ADDENDUM NUMBER 01

PROJECT: GRAVITY SEWER REHABILITATION PACKAGE NO. 7

OWASA CIP NUMBER: 276-18

OWNER: ORANGE WATER AND SEWER AUTHORITY

SHEET C-3
5 OF 6
276-18 JOB NUMBER

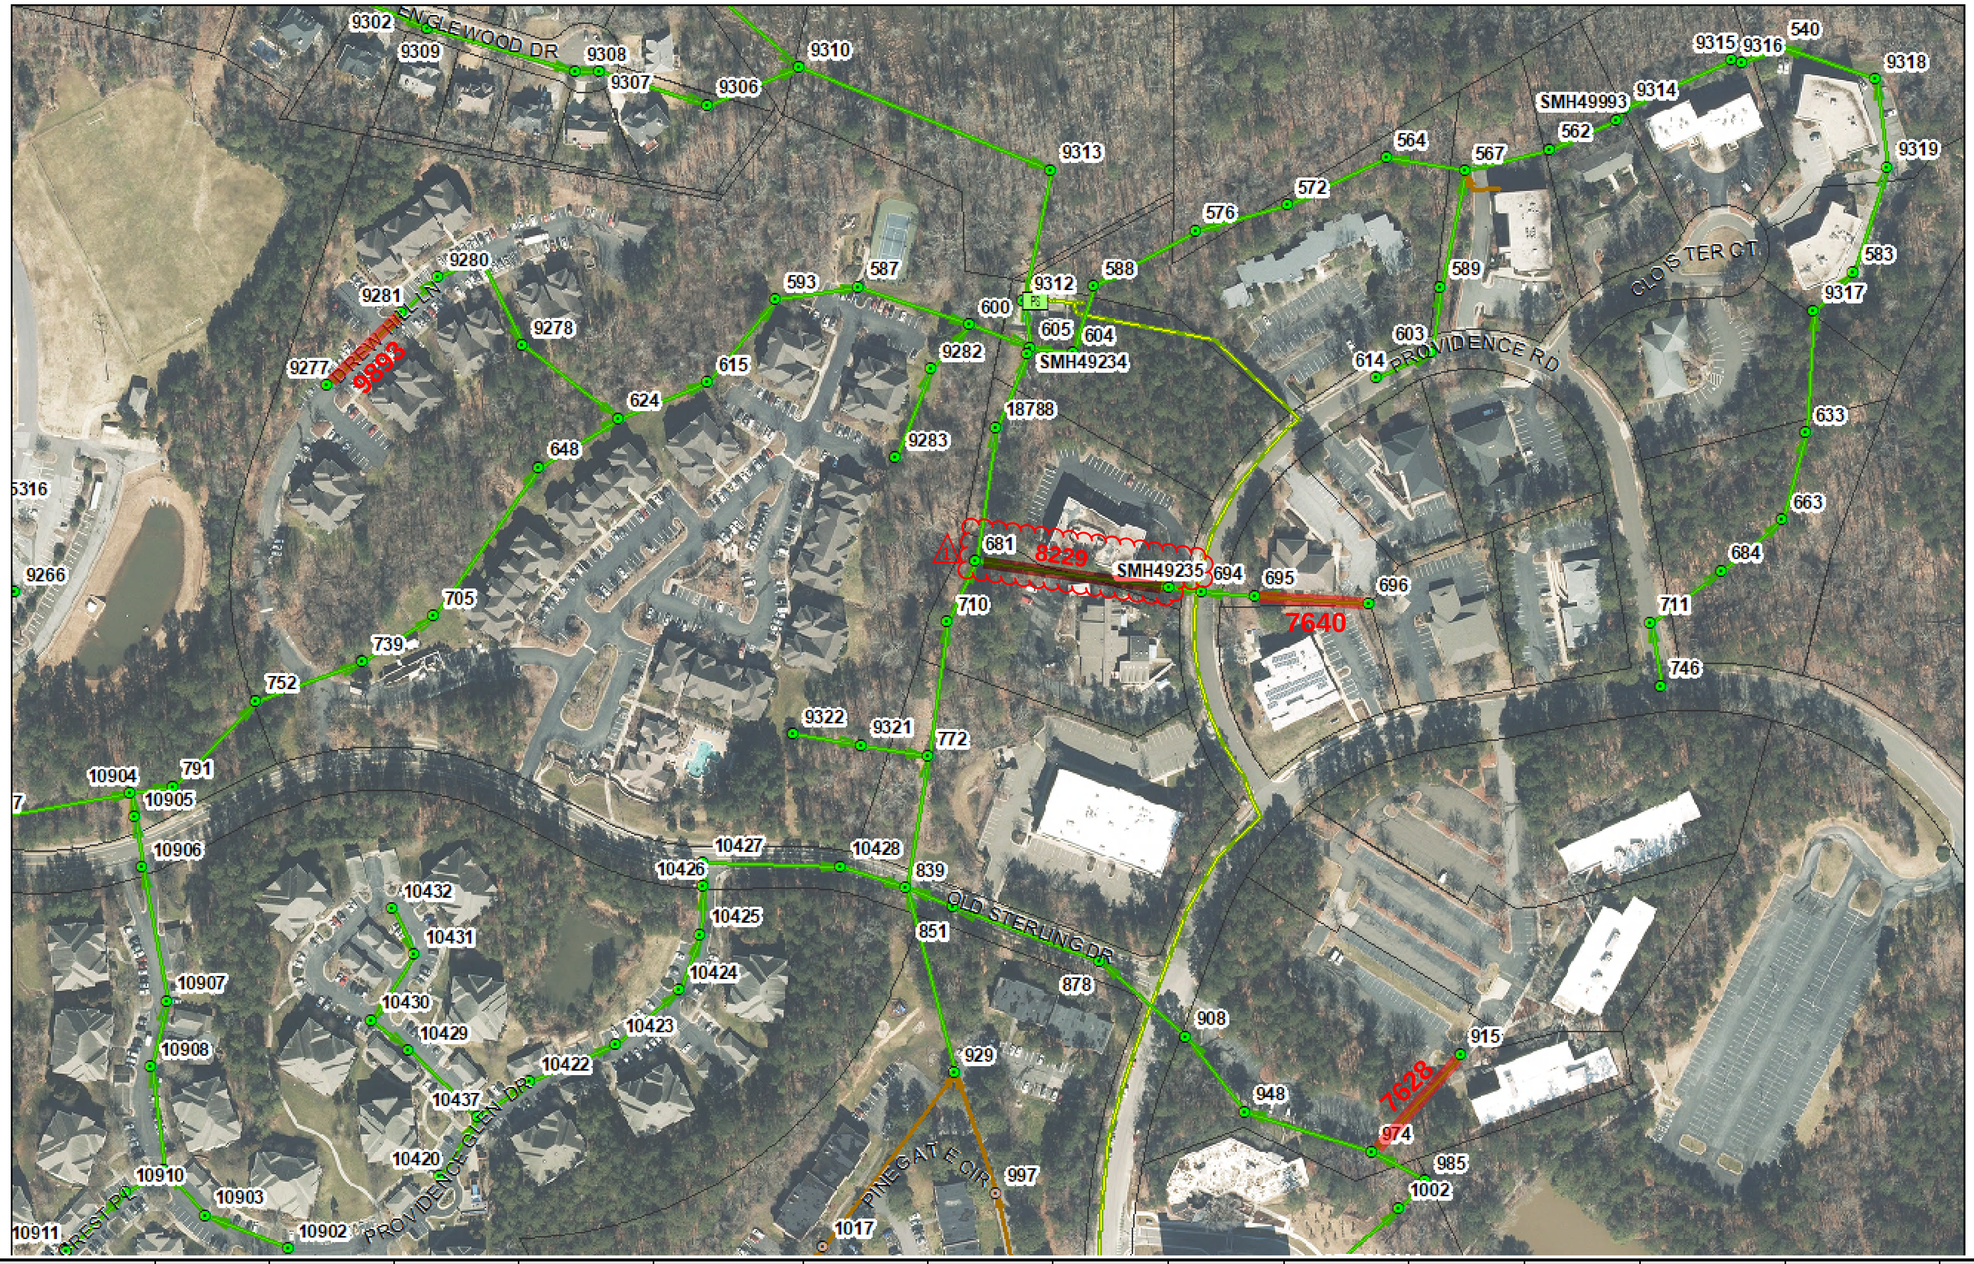
1. DRAWING SHEET C-3 – replace with new Sheet C-3 adding Pipe Facility ID 8229 to scope.

AREA 3 - LOCATION	PIPE FACILITY ID	UPSTREAM MH ID	DOWN-STREAM MH ID	PIPE DIAMETER (INCHES)	PIPE LENGTH (FEET)	PIPE MATERIAL	UP MH DIAMETER (FEET)	UP MH DEPTH (FEET)	UP MH REHAB (YES / NO)	DOWN MH DIAMETER (FEET)	DOWN MH DEPTH (FEET)	DOWN MH REHAB (YES / NO)	APPROVED MH REHAB METHOD	NUMBER OF SERVICE CONNECTIONS	APPROVED PIPE REHAB METHOD
Drew Hill Lane	9893	9277	9281	8	151	DI	4	UNKNOWN	NO	4	9.01	NO	Cementitious	0	CIPP
Providence Road	7640	696	695	8	169	VC	4	5.60	YES	5	8.90	YES	Cementitious	0	CIPP
Eastown Dr	7628	915	974	8	89	VC	4	13.65	YES	5	10.12	YES	Cementitious	0	CIPP
1 Providence Road	8229	SMH49235	681	8	290	VC	UNKNOWN	UNKNOWN	NO	4	5.14	NO	UNKNOWN	3	CIPP

NO.	REVISIONS	DATE
1	Bid Addendum No. 1	8/16/2022
